ACCESSION NBR: 8906070246 DOC. DATE: 89/06/05 NOTARIZED: YES DOCKET #
 FACIL: 50-250 Turkey Point Plant, Unit 3, Florida Power and Light C 05000250
 50-251 Turkey Point Plant, Unit 4, Florida Power and Light C 05000251

SUBJECT: Application for amends to Licenses DPR-31 & DPR-41, replacing Tech Specs w/TS submitted w/util 860929 & 1128 ltrs.

Re: Turkey Point Units 3 and 4
Docket Nos. 50-250 and 50-251
Proposed License Amendment
Revised Technical Specifications

FIGURE 5.1-1 SITE AREA MAP

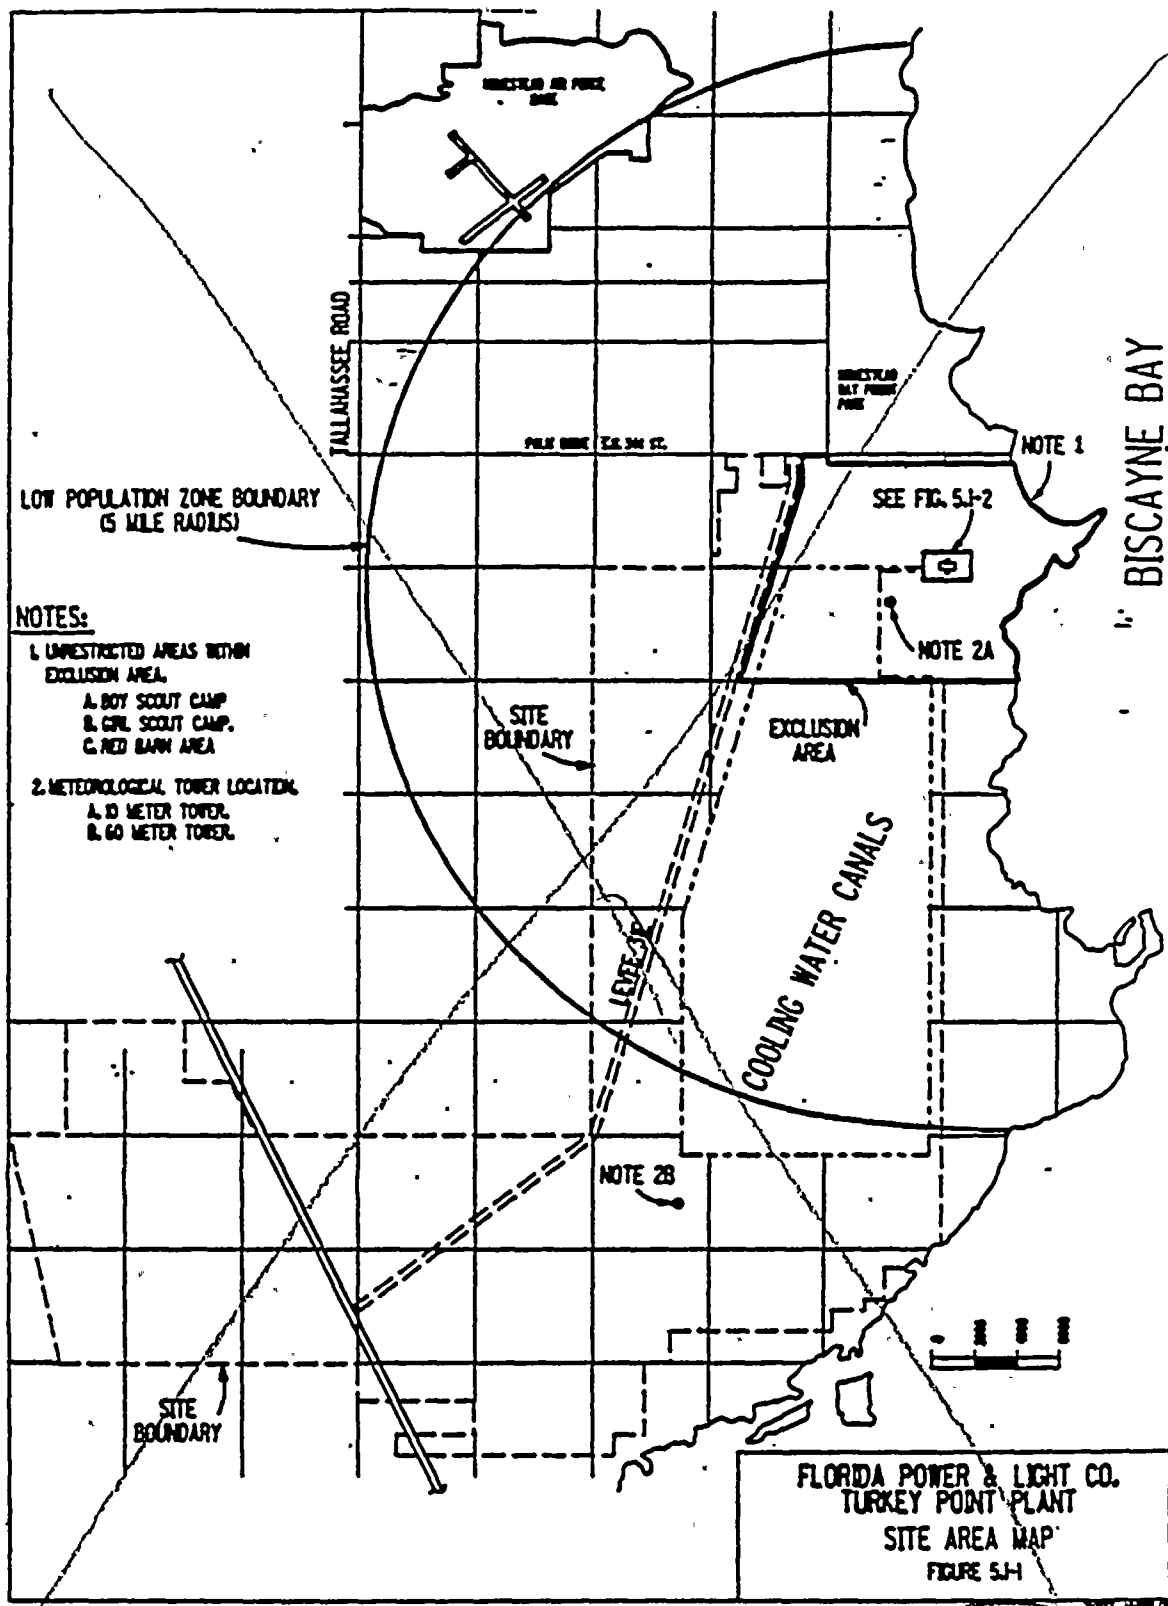
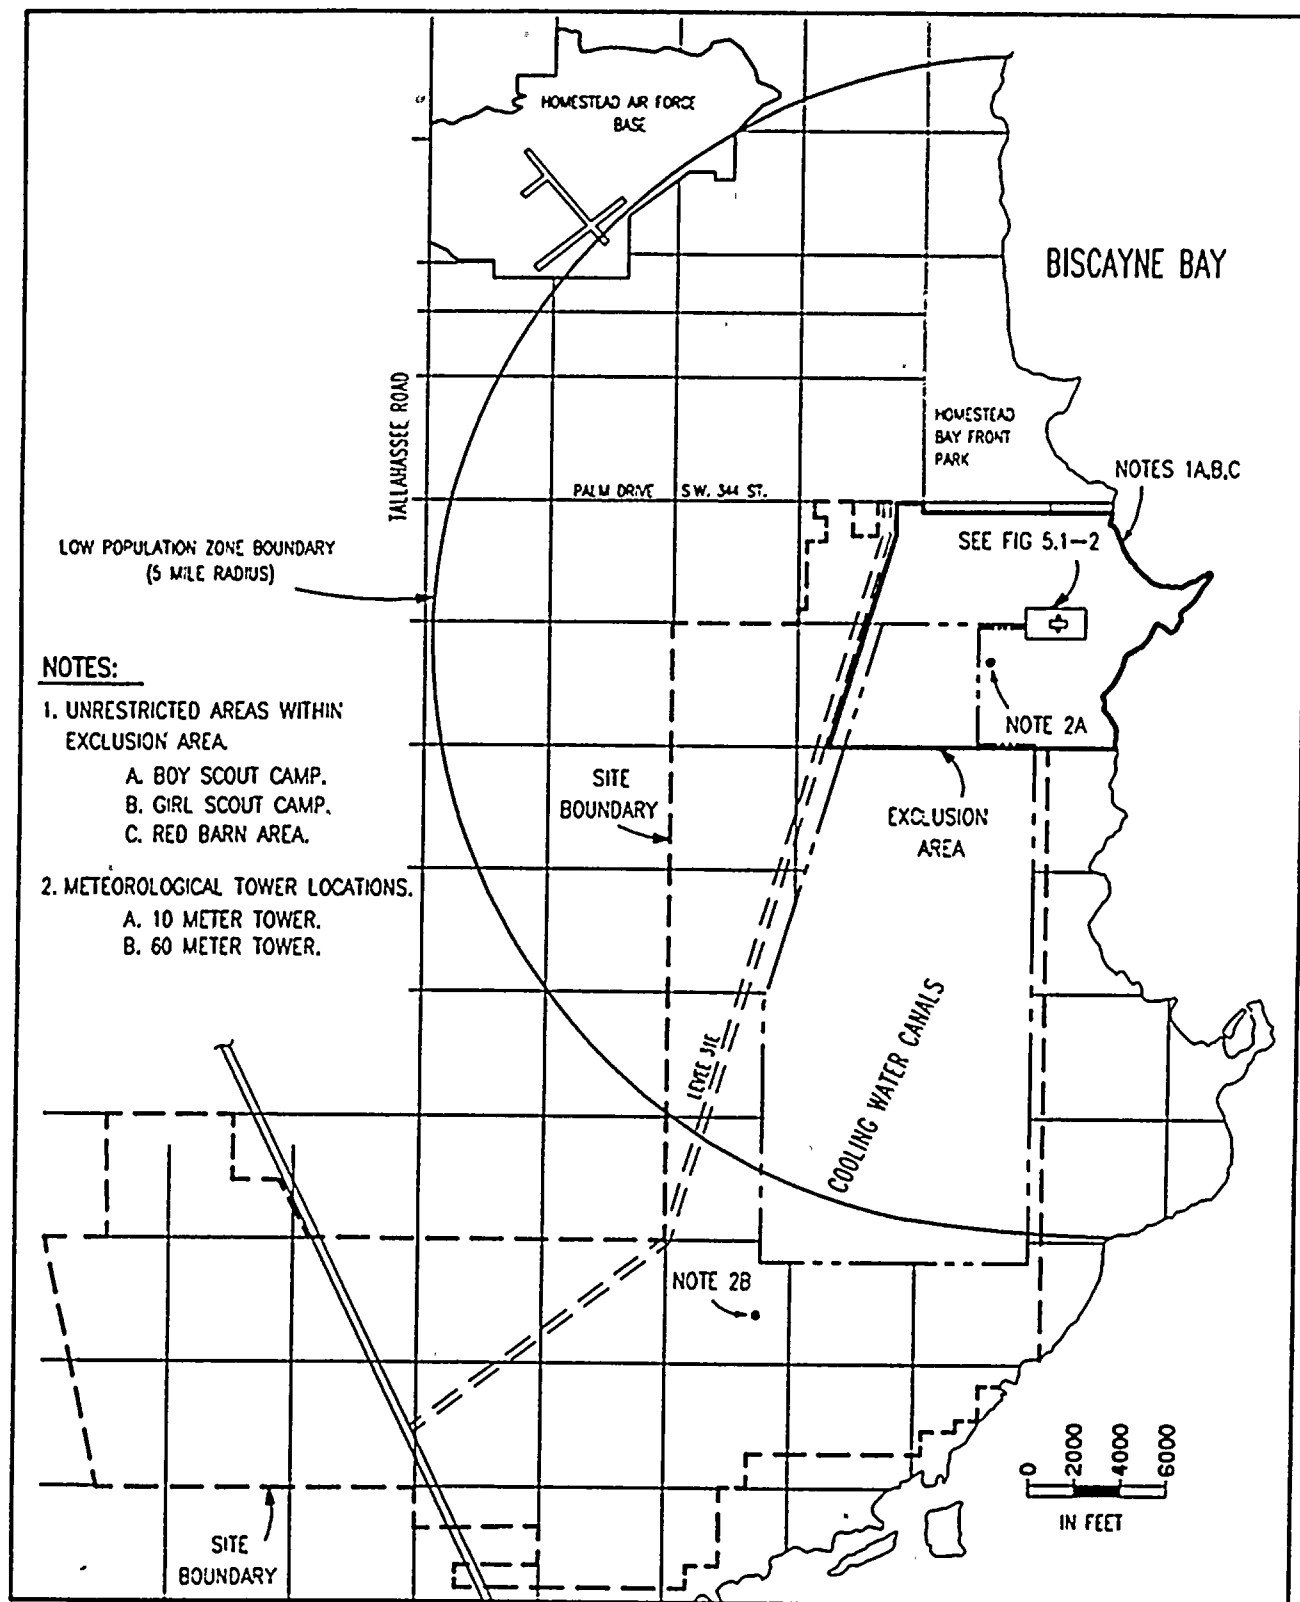
The locations of the Meteorological Towers are identified in the revised Specification Figure 5.1-1. Addition of this information is consistent with the Standard Technical Specification.

- 1) The proposed change as described in Item 2.a is similar to example (ii) of 48 FR 14870 in that it provides additional design information by including Meteorological Towers locations in the revised Technical Specification Figure 5.1-1.

5.5.1 The meteorological towers shall be located as shown on Figure 5.1-1.
